平成 27 年 6 月 23 日
運輸安全委員会

米国連邦航空局（FAA）に対する安全勧告に関するフォローアップについて

SPECIAL AIRWORTHINESS INFORMATION BULLETIN

SUBJ: Flight Controls

Figure 1 – Rudder Trim Switch

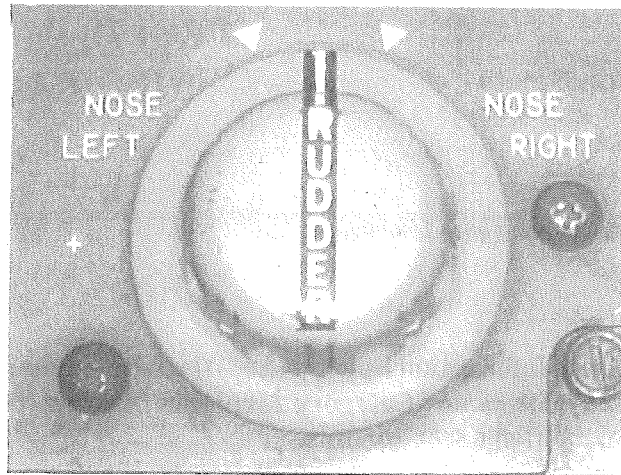
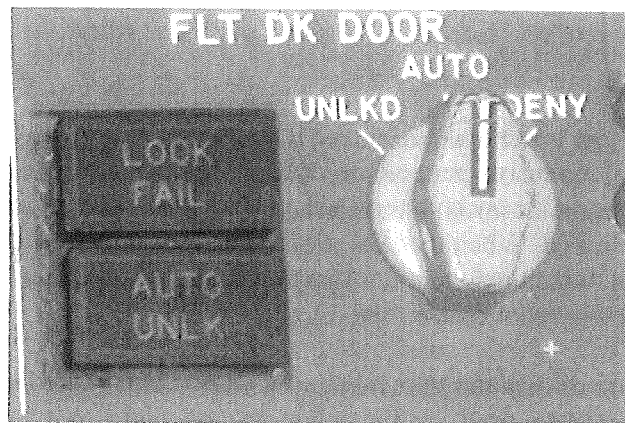
During the investigation of this incident, numerous aisle stand configurations were identified due to the multitude of supplemental type certificate installations and significant variability in the Boeing-delivered configurations. On the incident airplane (Model 737-700), the rudder trim switch is in approximately the same location as the flight deck door control switch on the operator's Model 737-500 airplane. This creates a potential for confusion when pilots transition between aircraft. Positive training on one model can become negative when the pilot transfers to a different model. Although the rudder trim switch (Figure 1) and flight deck door control switch (Figure 2) are different in size and shape (cylindrical vs. blade shaped), and the flight deck door unlock side of the switch must be depressed before turning, the general feel (spring force) to actuate the switches is similar; both are spring loaded to the center position. In this incident, the negative transfer error allowed the pilot to think he had operated the correct control, and the similarity of the control's operation exacerbated the situation.

In response to this incident, Boeing analyzed modifying the shape of the flight deck door control switch; however, they determined the position of the switch is more important than the shape of the switch from a human factors perspective. Position of a switch that affects pilot reach/posture provides better feedback to the pilot than the shape of the switch that the pilot feels. Boeing determined the most important factor to minimize inadvertent activation of the control switches is aisle stand configuration consistency within an operator's fleet.

Having a consistent position for the rudder trim switch is paramount because it provides a direct input to the aircraft rudder and can induce both yaw and roll into the aircraft flight attitude. Because both the rudder trim switch and the flight deck door control switch have a similar feel and action (turn and hold), a standard location and sufficient separation between these controls is recommended. Placing the controls in the recommended locations is consistent with most Boeing-delivered airplanes and creates a distinctive reach posture, provides sufficient separation in relation to reach direction from both seats, and provides adjacent tactile landmarks. This includes the railing in the corner of the aisle stand and the guarded stabilizer trim switch located between the rudder trim switch and the flight

For those operators, the FAA recommends minimizing aisle stand configuration variations within their fleets to prevent inadvertent actuation of the controls. If configuration variations are found, we recommend that the aisle stand layout be modified. When modifying the aisle stand layout, operators should always place controls in a location where they can get the most consistency within their fleets, and do the following, if possible:

1. Place the rudder trim switch in the center column as far aft as possible.
2. Place the flight deck door control switch in the far right column (first officer side) aft position.
3. Do not place the flight deck door control switch in the center column.
